Roof study · the maintenance ladder, the lowered attic, the low parapet with the set-back guardrail, the main cornice, the reserved zones · Taif / Palm House V8.1

Design review F-07 (major) · owner decisions 31 Oct 2026, V8.0 and V8.1 (the maintenance ladder, the roofline lowered) · flat roof, no tiles · the roof for maintenance and equipment only · no slab level changes · all sizes assumed until the engineer, the ladder supplier and the fall-protection specialist confirm

The roof access · the maintenance ladder in the suite court (owner, V8.1) · enlarged plan and section · the main stair stops at the first floor

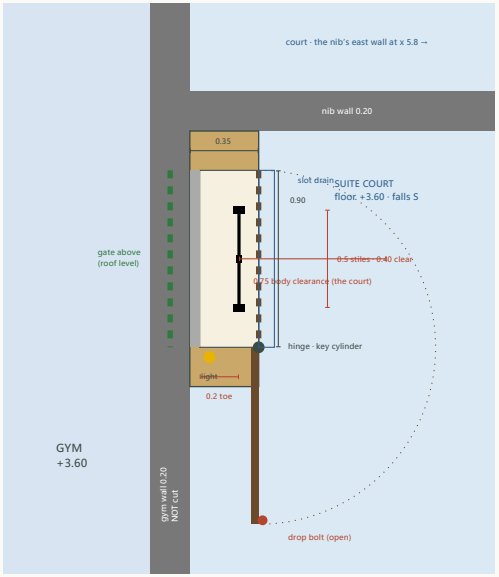
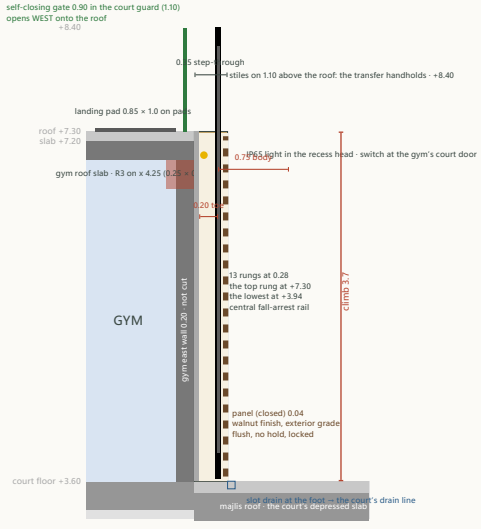
- **Owner's decision (V8.1):** a simple roof access (cost and appearance); office visitors are met in the men's majlis, the office is the owner's only, reached from the suite court. The roof is reached by a **manufactured vertical fixed ladder** (not site-made; black matte, non-slip rungs, corrosion-protected, aluminium or hot-dip galvanised and powder-coated steel) in the suite court, on the **gym's east wall**, at the north end of the wall against the nib: away from the seating (y ≥ 21.7) and off the door strip (y ≤ 20.55, x ≥ 5.9).

- **The recess:** 0.9 wide × 0.3 deep, full height from the court floor +3.60 to the gym roof +7.30, formed in a **honey-stone pilaster added on the court face of the wall** (1.3 × 0.35 m, cheeks 0.20): the 0.20 m structural wall on B19 (under R3) is **not cut**. If the engineer confirms that wall as non-load-bearing infill between B19 and R3, the recess may instead be cut into a locally rebuilt 0.50 wall and the pilaster disappears (structural coordination, X20). The pilaster's own weight (≈ 1.7 m³ block ≈ 20 kN) stands on the court's depressed slab: the engineer.

- **The ladder:** stiles 0.5 overall, rungs 0.40 clear, pitch 0.28, 13 rungs, the **top rung level with the roof finish** (+7.30), the lowest 0.34 above the floor; **toe clearance 0.2 m** behind the rung line (≥ 0.18), **body clearance ≥ 0.75 m** in front of it (the court, with the panel open); climb **3.7 m**. The stiles run on **1.10 m above the roof** (+8.40) as the transfer handholds (fixed, so no retractable grab post; if one is preferred it is mechanically fixed, never friction-held). Tools go up in a bag: both hands on the ladder.

- **The panel:** exterior-grade walnut-finish (marine ply or aluminium composite with a walnut veneer, 0.04 thick), hinged on the south jamb, **opens 180°** to lie flat along the pilaster line (x 4.7, y 21.75–22.65), held open by a **floor drop-bolt** away from the climber; a key cylinder outside (the key with the parents / the maintenance key); **closed it is flush with the pilaster face and offers no hold**: not climbable (children). With the panel closed the court reads a walnut panel in a stone pilaster, in the design language.

- **The arrival on the roof:** the climber steps from the top rung over the pilaster's top (0.35) through a **self-closing gate 0.90 in the court's west guard** (1.10 m, on x 4.25, directly above the recess), opening **west onto the gym roof**, onto a **standing landing pad** (x 3.3–4.15, y 20.8–21.8) inside the protected zone; from it the walkway north to the attic opening. The guarding is continuous from the pad to every piece of equipment (§ 3 check); the strip outside the set-back guardrail is a no-go zone.

- **Fall protection:** the climb (3.7 m) is over the 3.0 m threshold of EN ISO 14122-4: the ladder is specified with a **central fall-arrest rail** (EN 353-1 glider) rather than a cage, which would not fit the recess; the specialist confirms the arrangement under the Saudi requirements (SBC / Civil Defense / the labour safety rules) — **not verified here**. Anchor eyes on the attic wall for the no-go strips.

Sight lines · north–south section at x ≈ 1.4, looking west · the attic 1.38 m above the finish, set back 1 m · the parapet 0.7 m and the set-back guardrail · eye 1.6 m above the ground

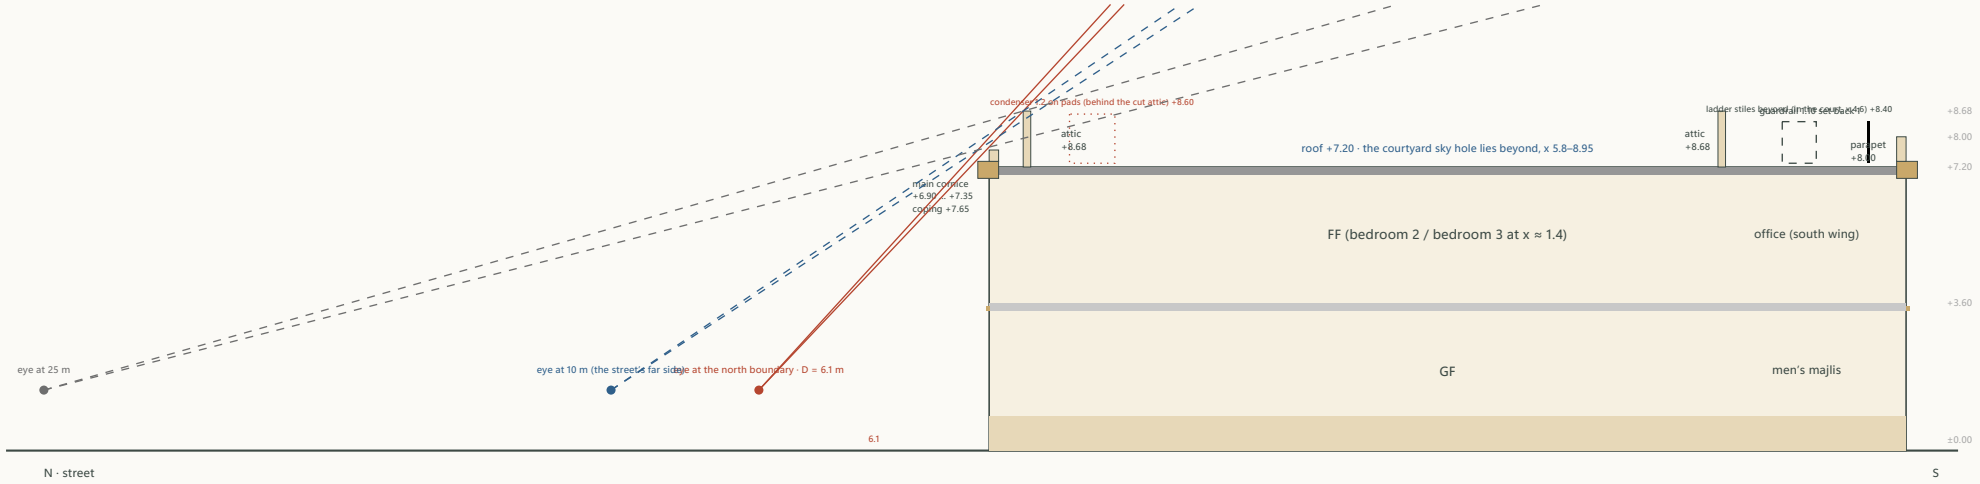
- **Attic height (owner, V8.1): 1.38 m above the roof finish, coping included** (top +8.68 was 1.80 / +9.10). **Re-run:** the minimum that hides the condensers from the street and the lane at eye level from every distance is 1.3 m (1.2 m units on 0.10 pads: top +8.60); 1.38 m leaves 0.10 m of margin, so **1.40 m works** on the condition that the outdoor units are **≤ 1.2 m high** (most 2–7 kW split and VRF condensers are 0.6–1.0 m; a tall unit laid on its side is not allowed: specify the height to the MEP engineer). The tank 1.0 m: hidden with 0.40 m of margin.

- **The HRV base** (+9.10) now stands 0.42 m above the attic coping: it is on the facade line in the cut tip, the plinth of the malqaf mass (seen by design, like the head). **Option** (owner / MEP): lower it to +8.68 with 1.25 m clear inside and 1.1 m doors (a horizontal unit ≤ 0.7 m); drawn: kept at +9.10 (1.65 m clear). The ladder's stiles (+8.40, in the court 2.4 m behind the court's south face) stay below the attic coping and are hidden from the south garden by the parapet up to ≈ 40 m; black matte.

North and west elevations · simple line drawings · the main cornice, the thin cornice between the floors, the lowered attic, the low parapet, the stepped roofline · openings indicative

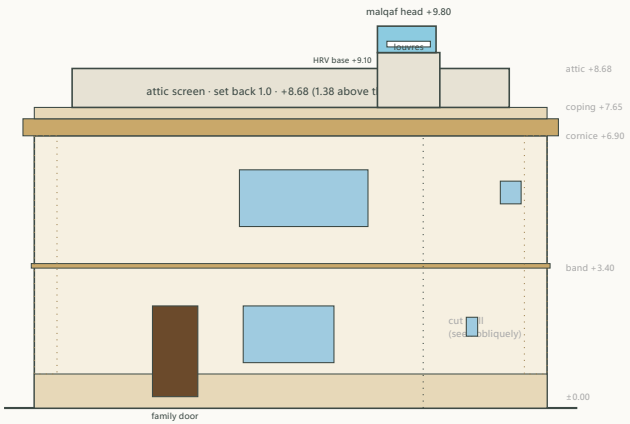
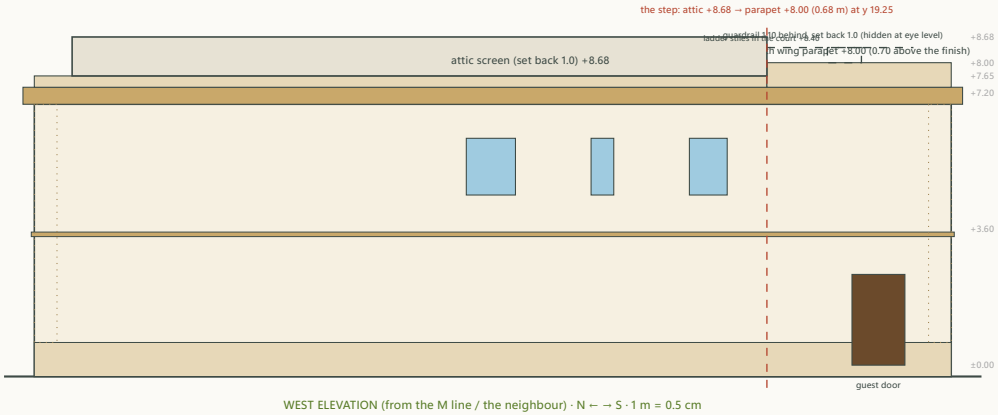
Cream plaster, honey stone at the plinth (to +0.60), the corners (quoins, dotted), the thin band at the first-floor slab (0.12 m, projecting 0.08) and the main cornice (0.45 m high, projecting 0.3, +6.90 … +7.35); the attic plastered cream with a stone coping. The south elevation repeats the west one's south part (parapet +8.00, the court's screened opening under the frame); the east elevation the north block's coping and attic (set back 1.0) over the kitchen / suite windows, then the parapet (the east elevation is drawn below). Openings are indicative here: the real ones are in the plans and the studies.

The cornice and the attic in section · loads for the engineer · what changes in the files

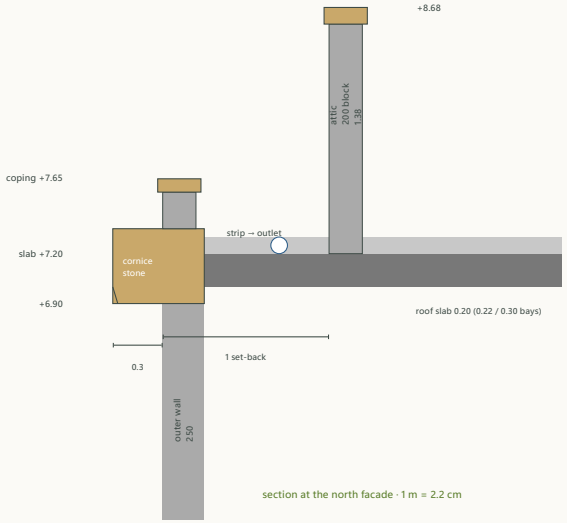
- **Attic (lowered V8.1):** 200 mm block, plastered cream, stone coping; 1.38 m above the roof slab + 0.10 coping = 1.38 m above the finish (coping +8.68); set back 1 m from the facade face (0.88 m from the wall centre lines); ≈ 58 m long; on the south on the y 19.25 line (B8 / R5). Four openings 0.80 (two to the strip, gated and locked; two to the south wing roofs).

- **South wing parapet:** 0.7 m above the finish, coping included (top +8.00); the **guardrail** 1.10 m black steel bars (posts at 1.5 m) set back 1 m from the outer faces, continuous from the attic's end walls to the court guards; the no-go strips 1.0 m.

- **Roofline step:** 0.68 m at y 19.25 (attic coping +8.68 → parapet +8.00), plus the 1.0 m plan set-back. **Final heights:** cornice +6.90 … +7.35, north coping +7.65, south parapet +8.00, attic coping +8.68, HRV base +9.10, malqaf head +9.80, ladder stiles +8.40 (inside the court). Targets, to confirm at the facade design stage.
